Access Compliance Report

Public Rights-of-Way

(Curb Ramps)

Intersection ID: 10656	Main Street: ASHLEY_RD	Cross Street: LINDBERGH_ST	Location:	N
ADA ID: 5E2747CD99D6	Ramp Type: Perp	Initial Pass/Fail: Fail	Overall Compliance: No	Severity Score: 1.25
Codes/Mitigation Info/Possible Solution		Field Measurements/Component Compliance

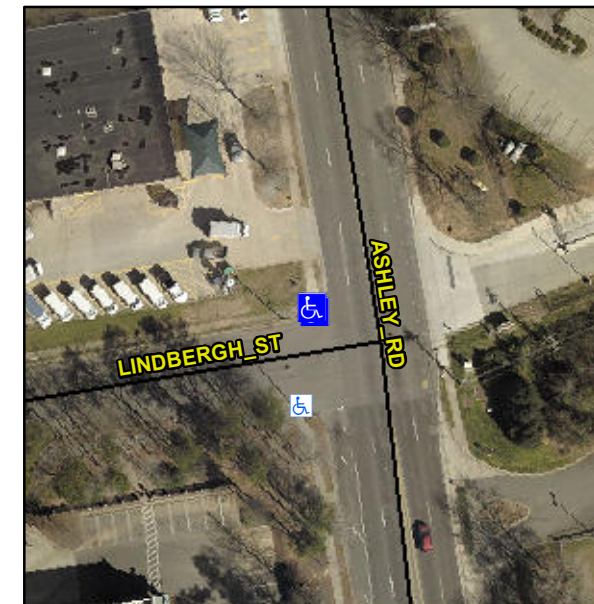
R304.5.3

Compliance	Description	Data	Compliance	Description	Data
N/A	Ramp Length (in)	90.0	Yes	Ramp Slope (%)	6.8
Yes	Ramp Width (in)	48.0	No	Ramp XSlope (%)	4.1
N/A	Flare Type LT	N/A	N/A	Flare Type RT	N/A
N/A	Flare Slope LT (%)	N/A	N/A	Flare Slope RT (%)	N/A
N/A	Flare Traversable LT?	N/A	N/A	Flare Traversable RT?	N/A
N/A	Landing Length (in)	N/A	N/A	DWS Provided?	N/A
N/A	Landing Width (in)	N/A	N/A	DWS Contrast?	N/A
N/A	Landing Slope (%)	N/A	N/A	DWS Length (in)	N/A
N/A	Landing X Slope (%)	N/A	N/A	DWS Full Width?	N/A
N/A	Landing Curb? (Y/N)	N/A	N/A	DWS Offset (in)	N/A
N/A	Shared Landing?	N/A			
N/A	Gutter Ponding?	N/A	N/A	Gutter Slope (%)	N/A
N/A	Gutter Lip Ht (in)	N/A	N/A	Gutter X Slope (%)	N/A
N/A	Painted X Walk1?	No	N/A	Painted X Walk2?	N/A
	X Walk 1 Direction	To S		X Walk 2 Direction	N/A
N/A	X Walk 1 Width (in)	N/A	N/A	X Walk 2 Width (in)	N/A
	X Walk 1 Slope (%)	1.0		X Walk 2 Slope (%)	N/A
	X Walk 1 X Slope (%)	2.9		X Walk 2 X Slope (%)	N/A

Remove & Replace Entire Ramp.
